Shaping Our Electricity Future EirGrid Industry Webinar

Questions and Answers

March 2022

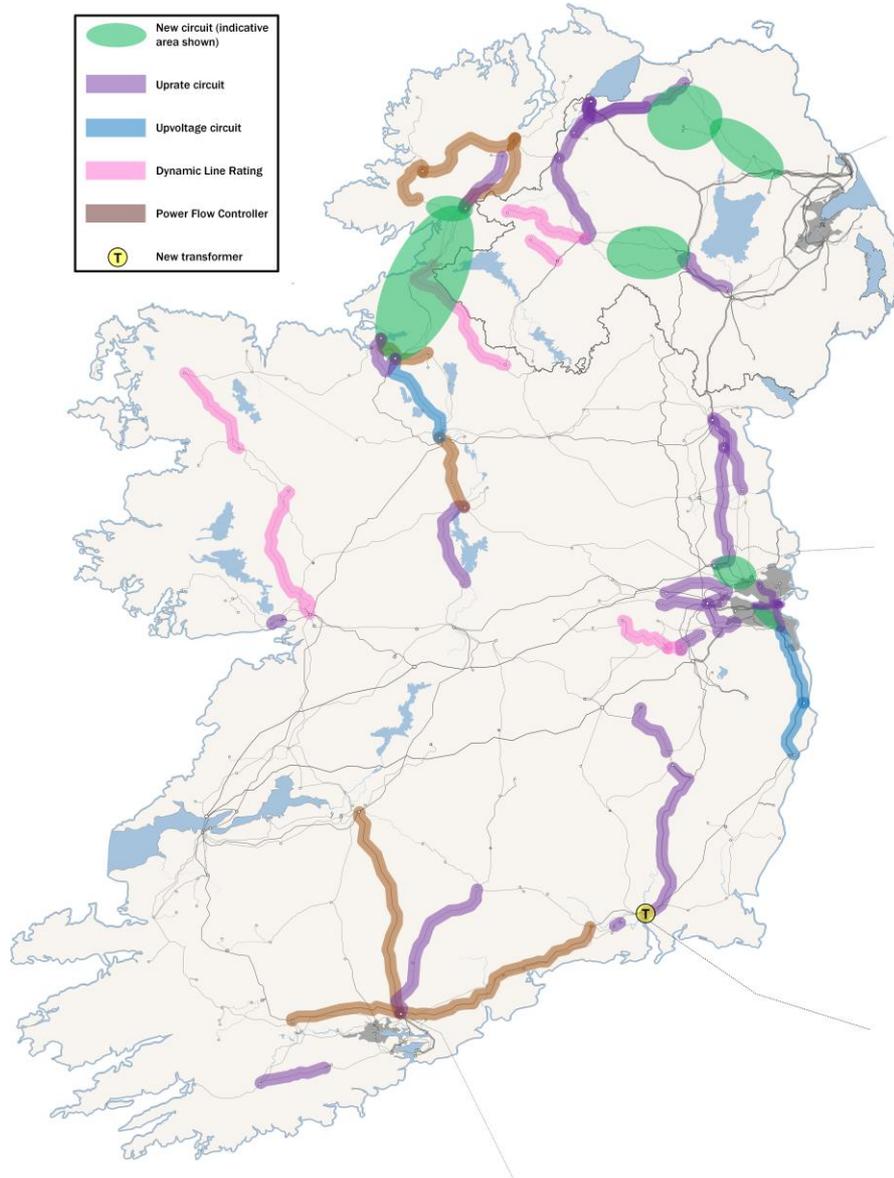
Question: Section 5.4.2 references a 220kV upvoltaged solution between Flagford and Srananagh (note that these two nodes are directly connected by one existing circuit which already operates at 220kV). Figure 5 suggests the Flagford – Sligo 110kV circuit will be upvoltaged to 220kV. Finally, Appendix 3 refers to an upvoltage of the Flagford – Srananagh 110kV circuit (note there is no 110kV circuit directly connecting Flagford to Srananagh), and an uprate (but not an upvoltage) of the Sligo – Srananagh 110kV circuit. There appears to be discrepancies between all of this information. Can you please explain what exactly is proposed for this project?

Response: There is an error in figure 22 in the SOEF roadmap document here. A corrected map is provided below.

Please note that the details provided in appendix 3 [here](#) are correct.
